Declaration of differences

FCC ID: IHDT56ZK2

Product description: Mobile Phone

Type designation(s): XT2091-3/XT2091-8

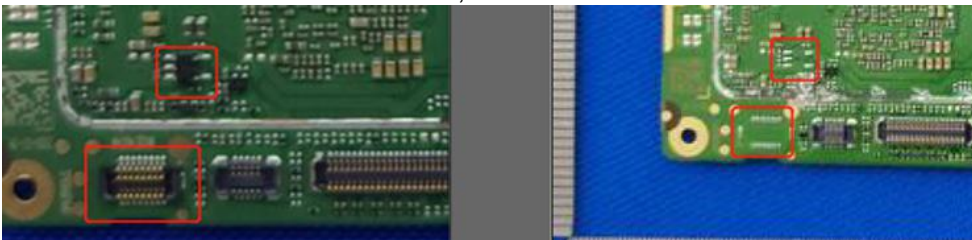
The original and the Variant difference is PA and filter, GSM part PA amplification, 3G/4G part of the switch , details as below.

The missing connector in the figure on the right is for debugging, when we entered the MP stage, we deleted the connector for it's useless, the others are the same.
